MITSUBISHI FUSO
TRUCK OF AMERICA, Inc.

RE: CAB LATCH LOCK INDICATOR RECALL S3026120 - 04V-437
CAB TILT MAIN HOOK RECALL R3120420 - 04V-436
FRONT HUB BEARING FH-FK RECALL R3123510 - 04V-478
FRONT HUB BEARING FM RECALL C0021113 - 04V-477

Recall Information Bulletin

Safety Recall R3120420 - Cab Tilt Main Hook

DIAGRAM 1

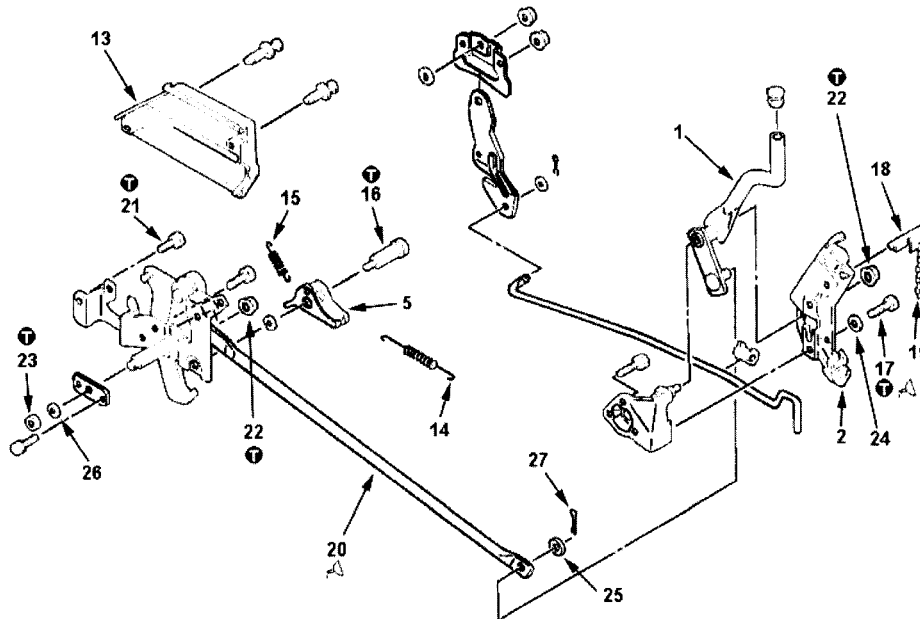
The tilt cab main hook assembly was modified to increase the clearance between the hook and the surrounding components while returning the cab latch mechanism to the locked position. The lock lever and the control lever bracket were modified to minimize assembly tolerance, which also assists in increasing the clearance between the tilt cab main hook and the surrounding components.

The cab main hook assembly (MC931140), lock lever (MC912231), control lever hook bracket (MC907591) and related parts will be replaced with modified components. The replacement parts are available through normal parts channels in kit form. The contents of the kit (part number is **KT642002**) are described on page 2 of this bulletin.

- Remove the main hook cover 13.
- Remove return springs 14 & 15.
- Loosen the lock lever bolt 16 and remove the MC912231 lock lever 5.
- Remove the MC931140 main hook assembly 20.
- Remove the chain 19 and key 18 from the control lever bracket 2.
- Remove the MC907591 control lever bracket 2.

- Install the new Control Lever Bracket (MC964520) **2** loosely, applying adhesive to the Control Lever Bracket Mounting Bolt **17** threads, as described in the Adhesive and Lubricant table above.
- Install the new Main Hook Assembly (MC964511) **20**, tightening the Mounting Bolts **21** as specified in the Tightening Torque table. Apply grease to the sections described in the Adhesive & Lubricant table.
- Install Return Spring **15** on the Main Hook Assembly **20**.
- Installed the new Lock Lever (MC964516) **5**, tightening the Mounting Bolt **6** as specified in the Tightening Torque table.
- Install Return Spring **14** on the Lock Lever **5**.

DIAGRAM 2

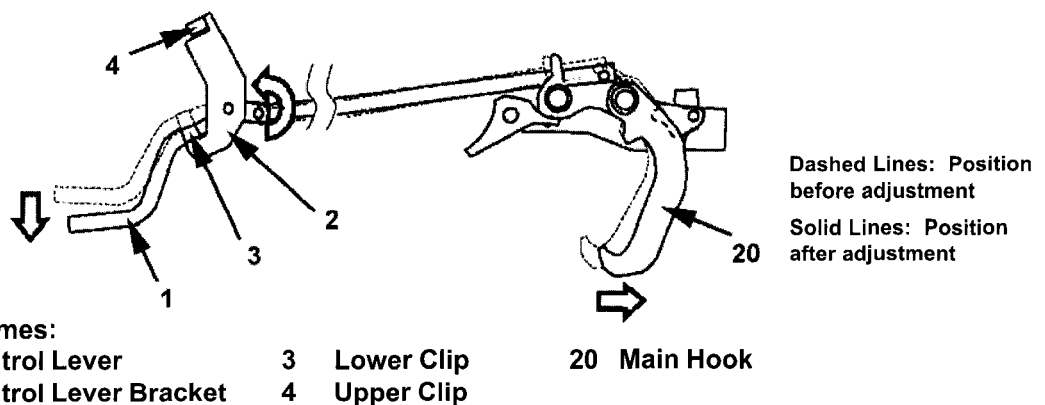
5. Main Hook Assembly Adjustment (refer to DIAGRAMS 1 and 2):

- Pull the Control Lever **1** down, latching it securely into the Lower clip **3**.
- Continue to pull down on the Control Lever **1** until it stops. This will fully seat the Control Lever Bracket **2** on its Mounting Bolts **17**.
- Continue to apply downward pressure on the Control Lever **1** and tighten the Control Lever Bracket Mounting Bolts **17** as specified in the Tightening Torque table.
- Install the Key **18** and Chain **19** on the Control Lever Bracket.

PHOTO 1

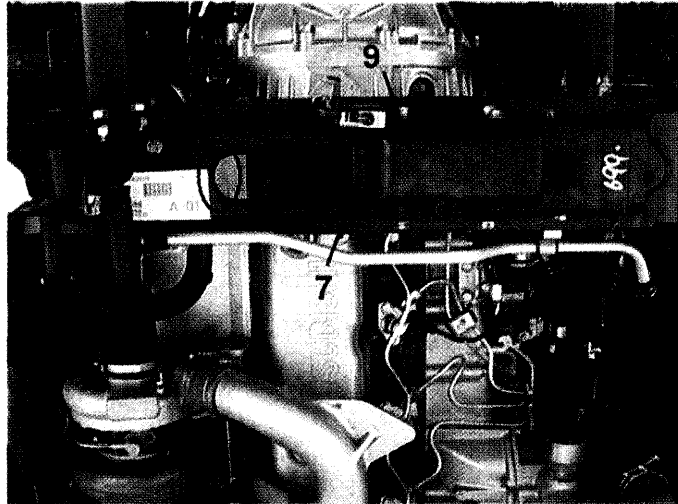
- Check for evidence of contact between the Main Hook Assembly 20 and the Hook Pin Bracket 7, Cab Bridge 8, and Hook Hinge Bracket 9. Contact in these areas is unacceptable.
- Contact in the area indicated within the red oval is considered acceptable.

If the Main Hook Assembly 20 contacts the Hook Pin Bracket 7 or Hook Hinge Bracket 9, repeat all disassembly and reassembly procedures.

- Loosen the Bolts 28 and Nuts 29.
- Push the Cab Bridge 8 forward until the Main Hook Assembly 20 properly clears the Cab Bridge 8 without contact.
- Retighten Bolts 28 and Nuts 29 as specified in the Tightening Torque table

PHOTO 2

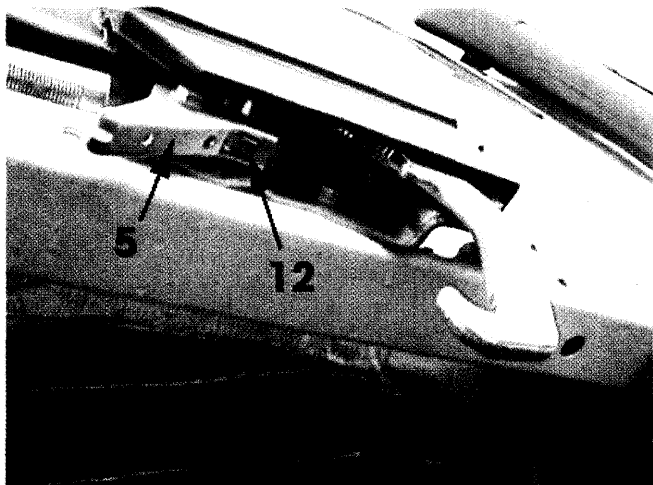
- Push upward forcefully on the Control Lever 1 while tilting the cab and confirm that the Lock Lever 5 does not disengage from the Main Hook Arm 12.
- Repeat the Final Operational Check three additional times using the following steps: Lower the cab, lock the cab tilt system, unlock the cab tilt system, tilt the cab, perform the check while tilting.
